**U. S. NUCLEAR REGULATORY COMMISSION
SAFETY EVALUATION REPORT ON**

**CENTRUS ENERGY CORP. REQUEST FOR REVIEW AND APPROVAL
OF AMERICAN CENTRIFUGE LEAD CASCADE FACILITY FINAL
STATUS SURVEY REPORT AND REQUEST FOR TERMINATION OF
DECOMMISSIONING FUNDING**

DOCKET NUMBER 70-7003

September 2019

Figure 2. Diagram of the X-3001 room using the location parameters provided in the updated Centrus evaluation.

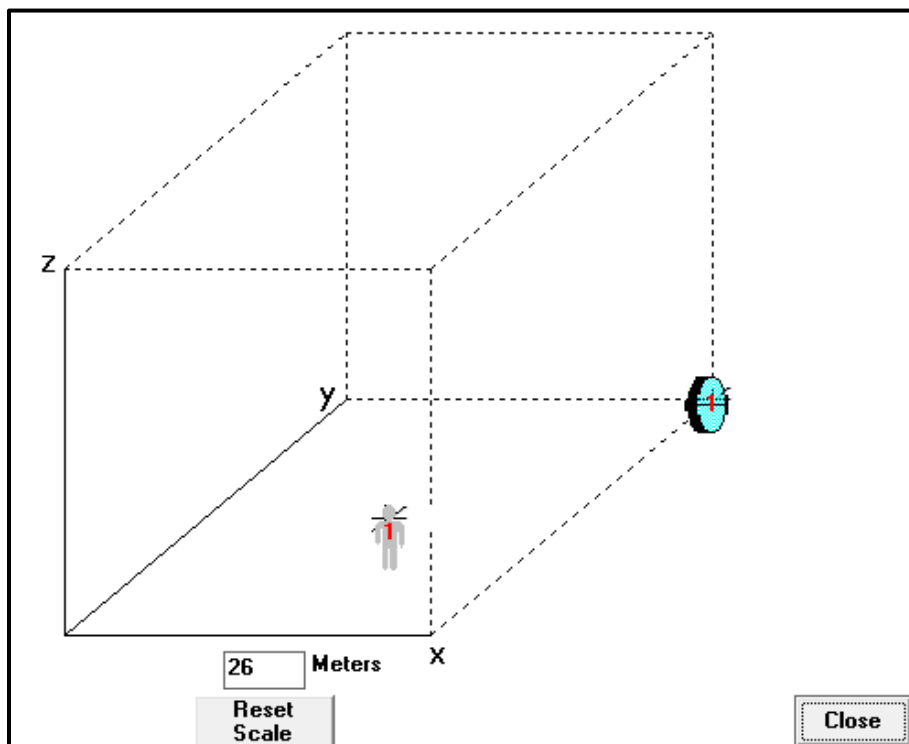
During its review of the DP, NRC staff noted that some of the parameters Centrus used in its RESRAD-BUILD analysis were not the most conservative. The dose assessment provided in the DP considered a single square room with an area of 676 m² and a ceiling height of 2.5 m with a 531 m² circular area of contamination within the footprint of the square room. The RESRAD-BUILD analysis also centered the contaminant source in the corner of the room while placing the receptor in the middle of the room.

Following discussions with NRC staff, Centrus revised its analysis and submitted an updated RESRAD-BUILD analysis that considered contamination throughout the entire 676 m² room (ADAMS Accession No. ML18129A390). Figure 2 below provides a three dimensional diagram of the revised RESRAD-BUILD scenario evaluated by Centrus. Although this updated analysis was more conservative than the original submittal it still centered the contamination in the corner of the room and placed the receptor in the middle of the room.

Figure 3. Diagram of the X-3001 room using the intended location parameters to describe the maximum dose received by individual located in the center of the room.

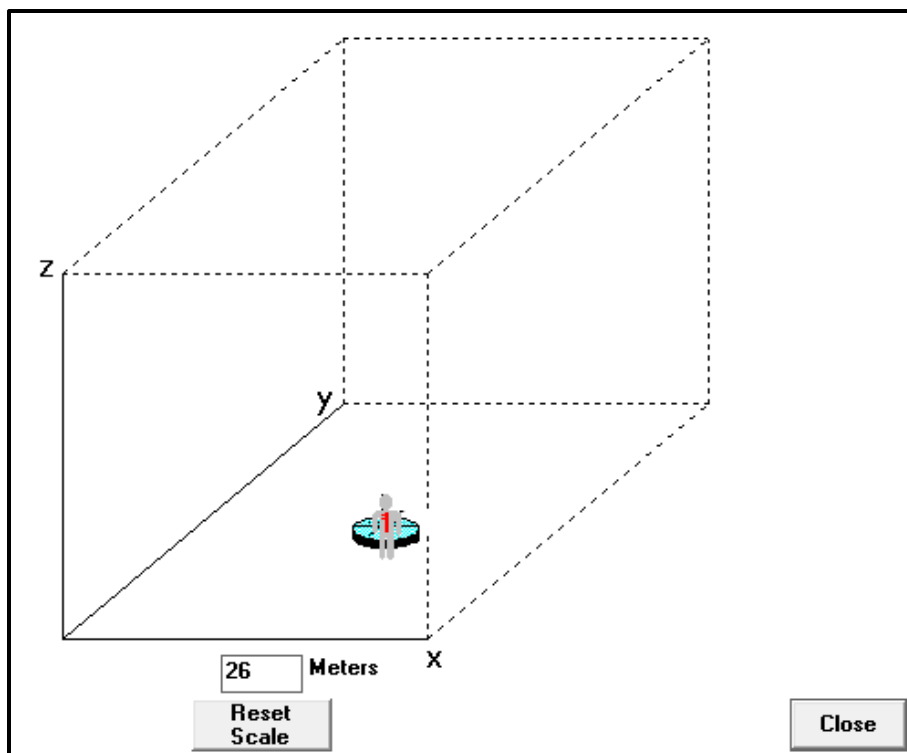
Instead of issuing a second round of requests for additional information (RAIs), NRC staff performed an independent analysis to calculate doses associated with the more conservative exposure scenario. NRC staff modified the coordinates of the source to locate it on the floor in the center of the 26 m X 26 m room (X= 13, Y= 13, Z= 0). Using the guidance provided in

Section 2.3 of ANL/EAD/03-1, “User’s Manual for RESRAD-BUILD Version 3” (ANL, 2003), which indicates that the location of the calculated dose deposited within the receptor should be at the midpoint of the receptor, NRC staff also located the receptor in the center of the room, but 1 m above the floor (X= 13, Y= 13, Z= 1). Figure 3 provides a three dimensional diagram of the locations used in the NRC staff’s conservative RESRAD-BUILD analysis. It is important to note that the sizes of the circles identifying the contaminated areas in Figures 2 and 3 are not representative of the areas of contamination; the RESRAD-BUILD three dimensional diagrams are intended to demonstrate the location of the receptor and the center of the contaminated area. Using the U-234, U-235, and U-238 concentrations equivalent to the 5,000 dpm/100 cm² provided in Table 1 and these updates to the locations of both the contaminant and receptor NRC staff calculated a minimal increase in the dose from 0.0319 mSv/y (3.19 mrem/y) reported by Centrus to 0.0325 mSv/y (3.25 mrem/y).
